Rev 1: September 2018  
FSN Ref: M21031-2

## **Urgent Field Safety Notice** **Moviplan 800**

### **Service Note NIM03-2021**

N. NIM003-2021  
*Date:* *November 3, 2021*  
*Subject:* *Pin soldering verification*  
*To:* *Villa dealers*  
*Equipment:* Moviplan 800

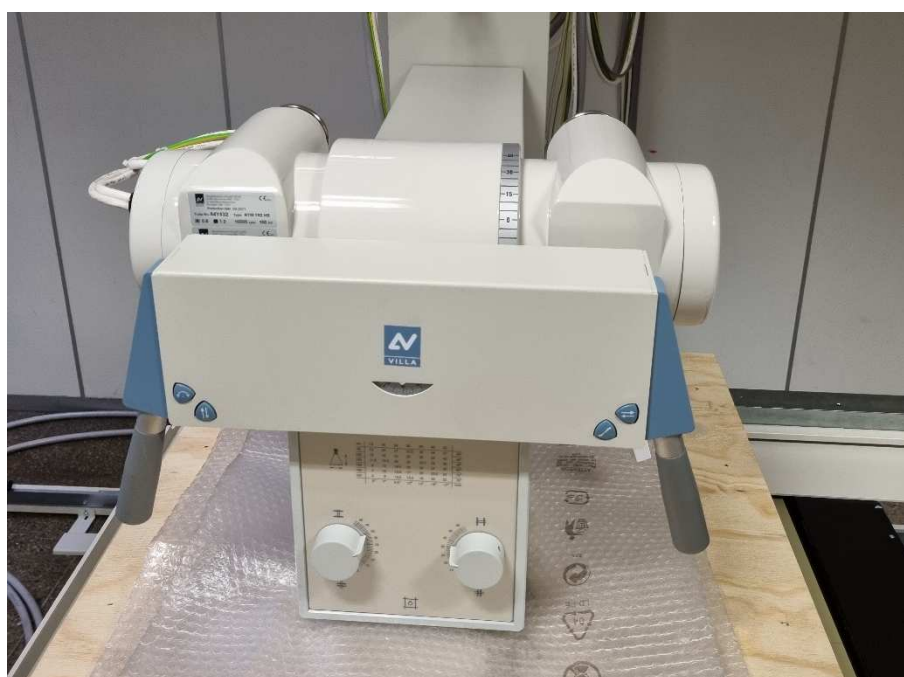
With this Note, we inform you that the some tube support shaft mounted on Moviplan 800 columns manufactured between April 2020 and March 2021 could have a non compliant welding due to the dimension of the welding throat.

Just for reference, here following the type of verification to be done in field on installed units, where it is visible, without dismounting x-ray tube, the difference between correct welding, that should have the weld throat size of about 4mm, and non compliant welding

In green you can see the correct weld throat size

For better understanding, here following the differences between a correct welding (green arrow) and a non compliant welding (red arrow).

In case you find this type of welding, it is required the tube support replacement.

In case it is necessary the replacement, the spare part code is:

*6174791100 Tube support for Moviplan 800 column*

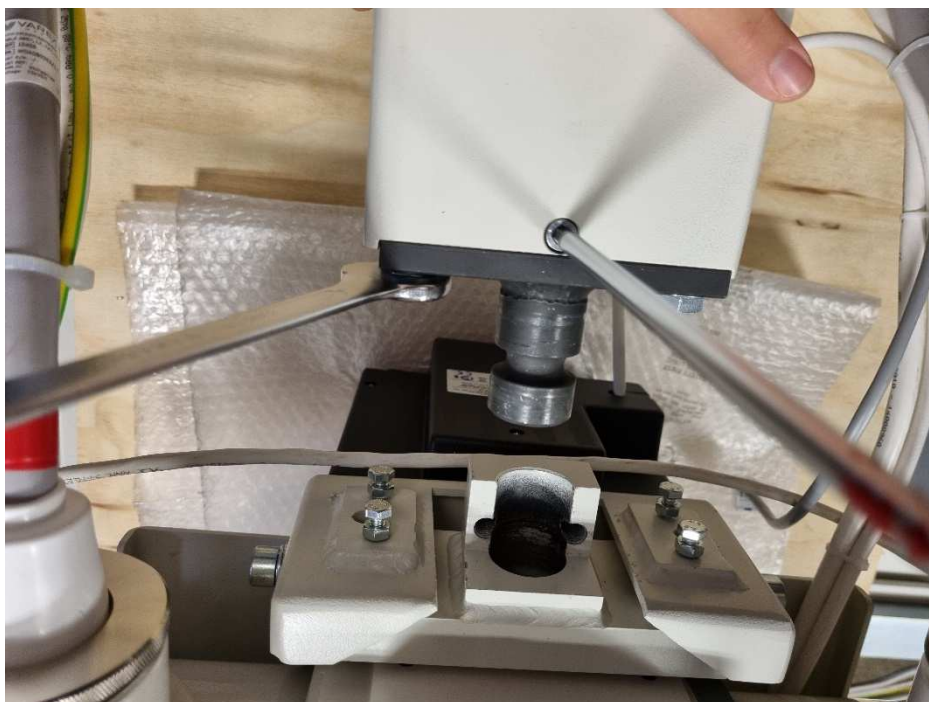
Remove the upper block screws

Pull out the tube group and leave it on the table top

Take a reference of the actual pin position

Remove the three fixing screws before the lateral ones, then the middle one

After pin replacement, mount the tube group, and verify if tube and column are at the same level using an air bubble. Fix the screws. Before fixing the grub screws, verify x-ray beam alignment
